Subject: Sequoyah Fuels Corporation, Doçket – 40-8027
Response to Request For Additional Information – Reclamation
Plan – Radiation Protection and Erosion Protection (TAC L52528)

**Sequoyah Fuels Corporation
Reclamation Plan Review**

Partial Response to Request for Additional Information

SEQUOYAH FUELS CORPORATION SITE CHARACTERIZATION REPORT	
BACKGROUND SAMPLE LOCATIONS	
PREPARED BY:	SFC
REVIEWED BY:	RM
DATE:	01/21/05
FILENAME:	SFC0040A
FIGURE NO. 21

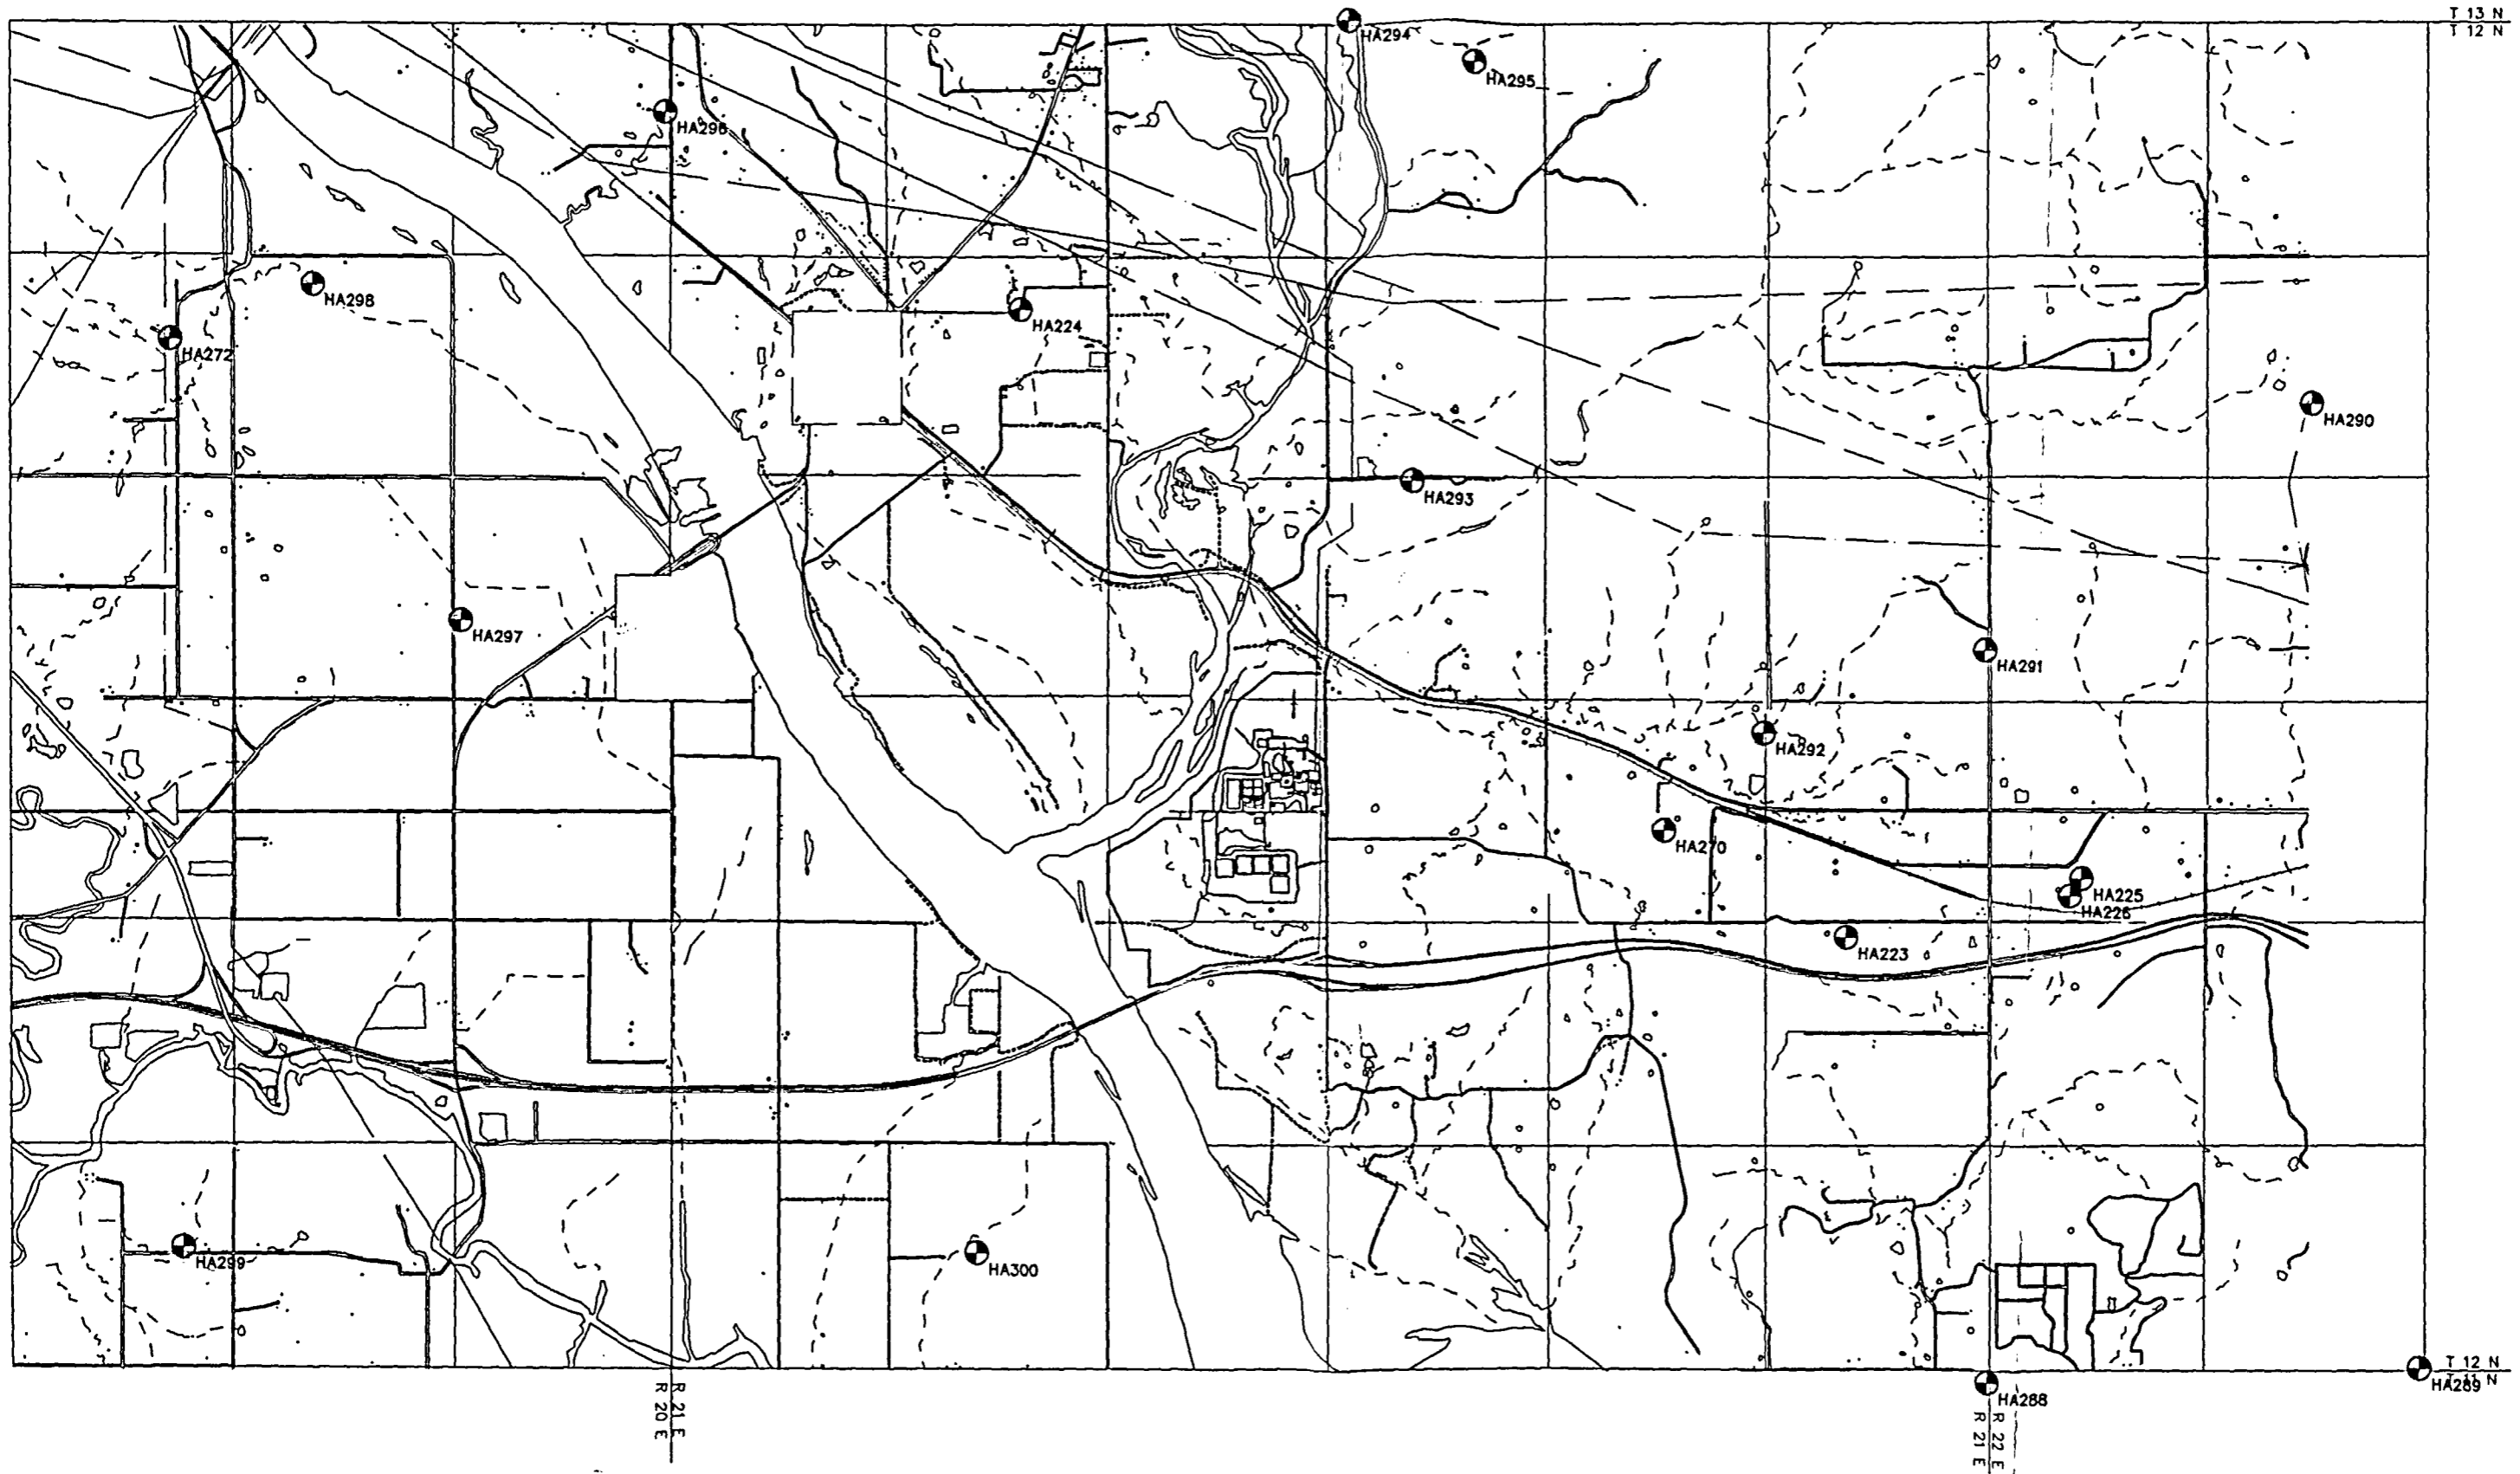
H BASIS: Part of establishing soil cleanup levels is the appropriate establishment of background levels. Appendix D, Section 4.1.1, indicates that 31 soil samples were collected and analyzed, but that additional sampling will be required for Th-230 and Ra-226 because of problems with two analytical labs. The staff cannot approve of cleanup levels without evaluating the proposed background values, since background is part of the regulations in Criterion 6(6).

REQUEST: Provide the background radiological data for the surface and subsurface soil. Discuss how the sample locations are geochemically representative of the contaminated areas and why two samples are from 12 miles away instead of at the fence line (indicate unit of length on Figure 21), why the variation in sample results is acceptable, and how all these processes/procedures are the same or very similar to those in the final status survey plan.

Sample locations HA307 and HA308 are not included in the table of background soil sample results in Attachment 4. These locations were originally selected in conjunction with an EPA evaluation of SFC's ammonium nitrate fertilizer application program.¹ These soil sample locations may not satisfy the condition for background sample locations with minimum anthropogenic influences. Note however that the EPA concluded the "application of ... fertilizer did not affect the soil within the fertilizer application areas or surrounding off-site farmlands".

The legend of Figure 21 has been revised to reflect the applicable unit of length. The revised figure is included in Attachment 4 to this response.
